Title: TOP & POWER

Project: NUCLEO-XXXXXXX			
Size: A4	Reference: MB1136	Revision: C.3	
Date: 9/26/2014		Sheet: 1 of 4	life.augmented

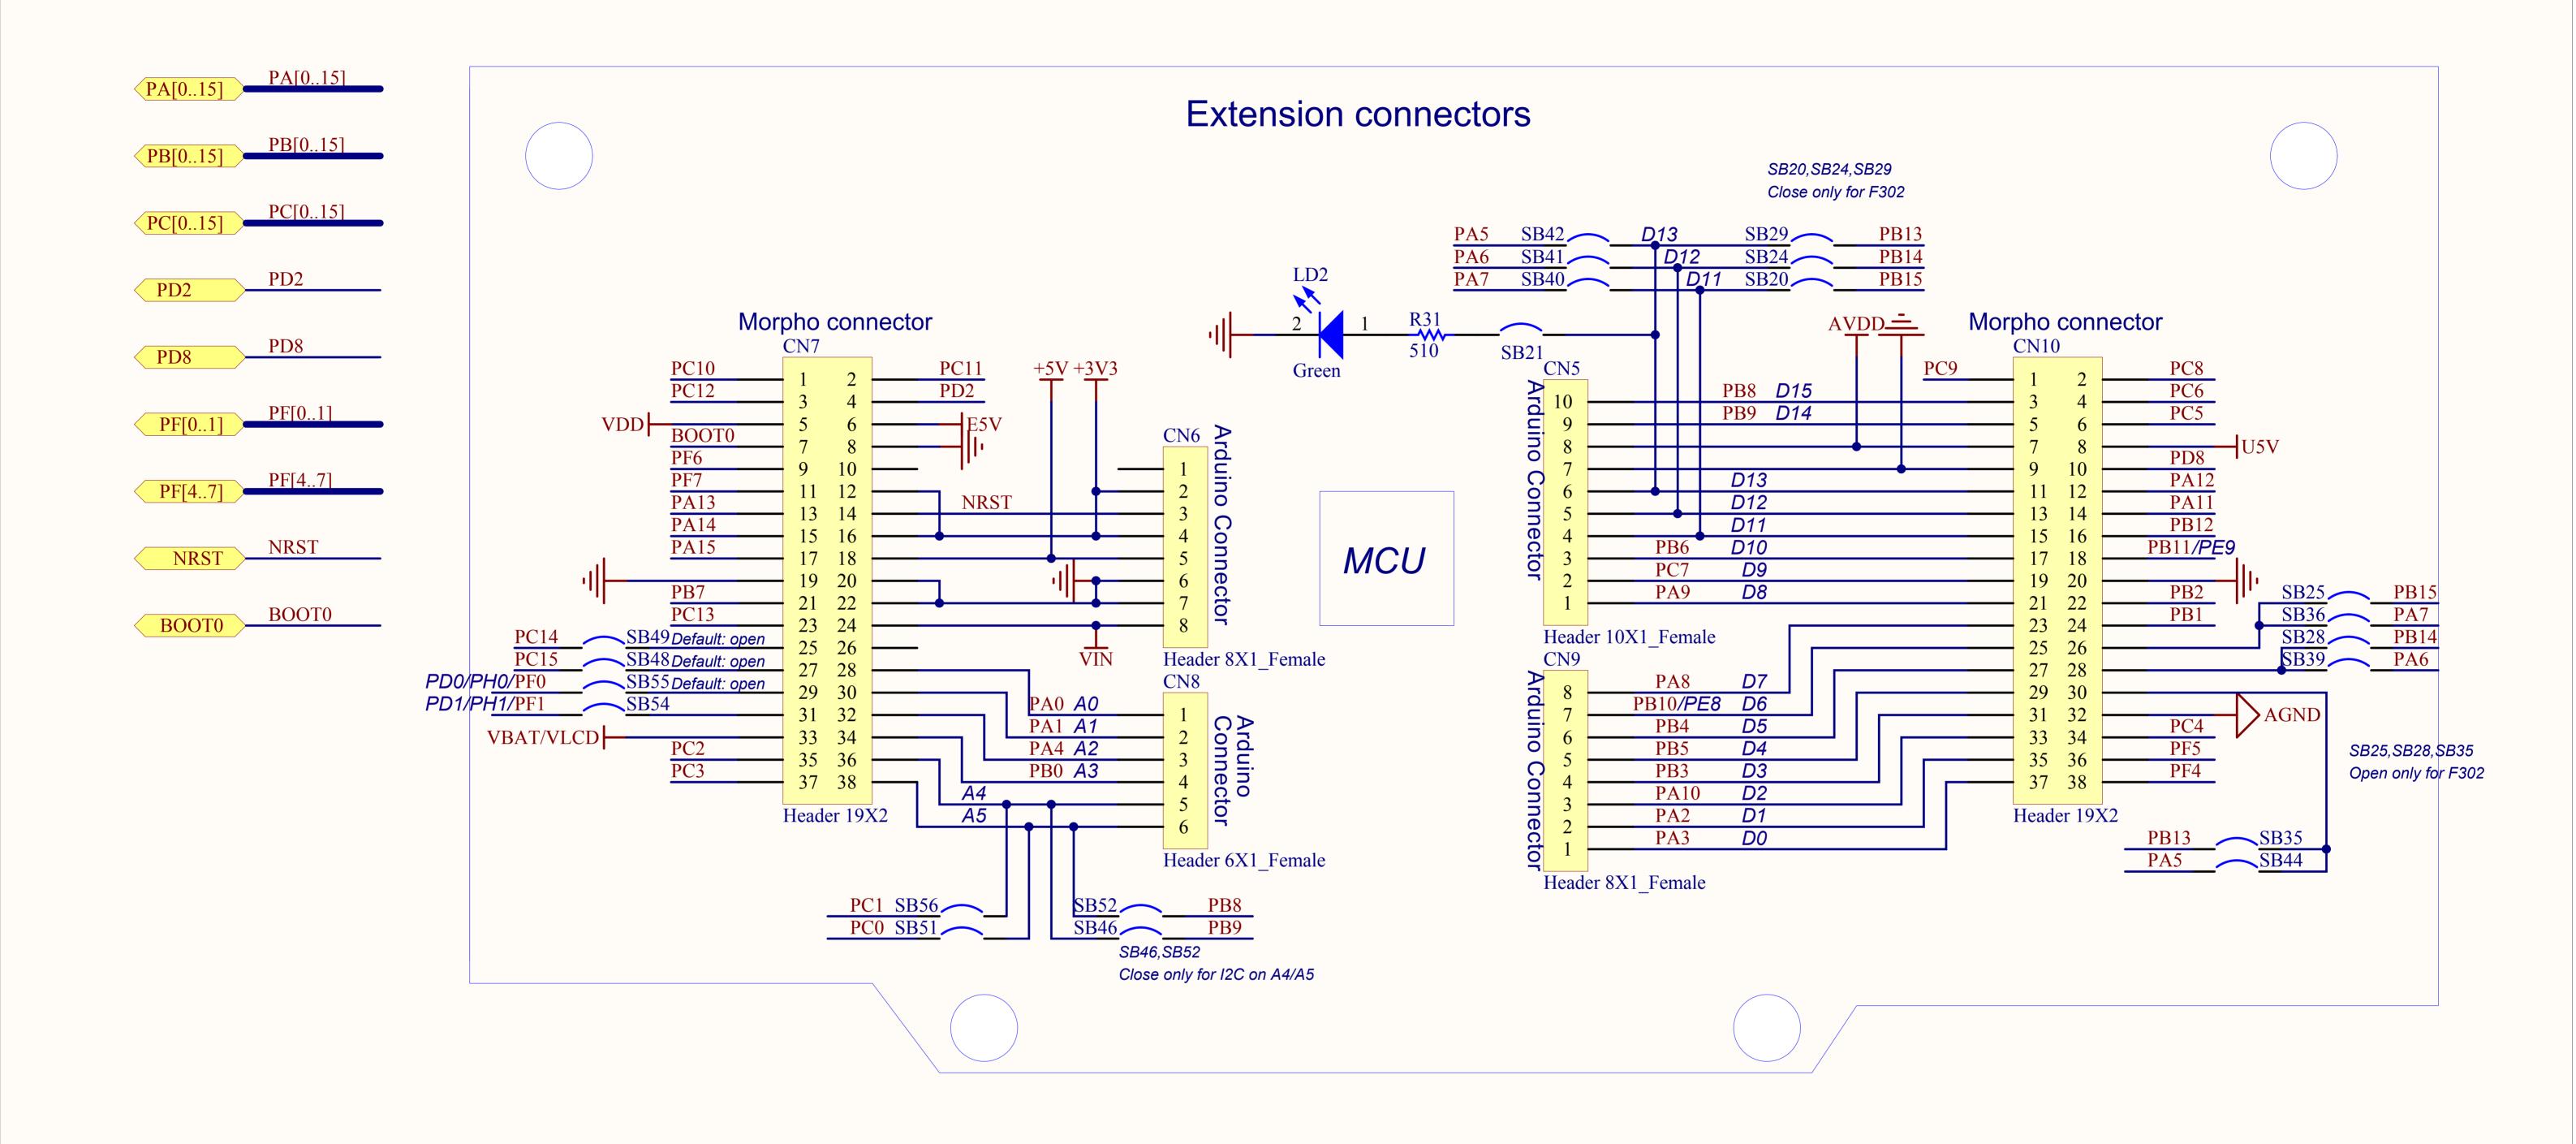
Note2: Remove [N/A] on R34, R36, C31, C32, X2 from C.1 to C.2

Note3: Add "default open" on SB48, SB49, SB55 from C.1 to C.2

Note4: Replace "default open" by "default closed" on SB16 & SB50 from C.1 to C.2

Note5: C31&C32 value changed from 10pF to 4.3pF to fit with new 32K crystal ABS25-32.768KHZ-6-T
